- A. MerCruiser 888 Overheating
- B. MerCruiser 280II-TRS Stainless Steel Propellers
- C. New MerCathode Replacement Parts
- D. New Trim Limit Switch Replacement Procedure

A. MERCURISER 888 OVERHEATING

(Attach Bulletin Reference Sticker to P. 6B-1 of Your Service Manual.)

Figure 1. Drilling into Water Pickup Hole

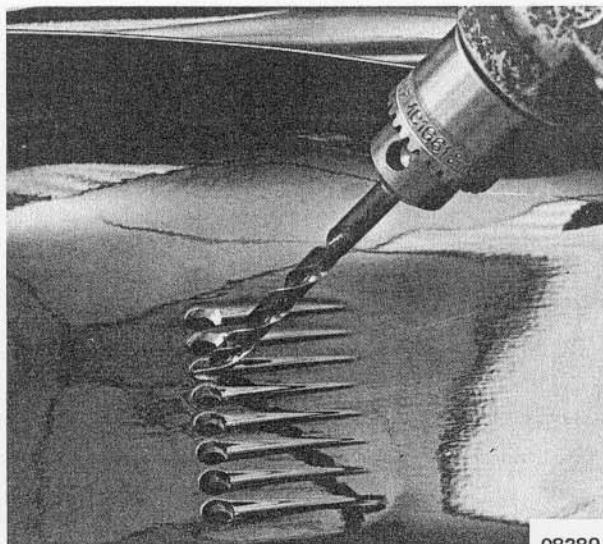
1. Drill perpendicular into top water pickup hole with a 1/4" drill, allowing the drill to penetrate only slightly into the cavity. (Figure 1) Rotate the drill slowly toward the front of the gear housing, keeping it parallel to the cavitation plate until a 45° angle is reached. (Figure 2)

CAUTION: DO NOT allow the drill end to penetrate deeper than the housing wall thickness. Should the drill penetrate into the exhaust cavity, it would damage the gear housing beyond repair.
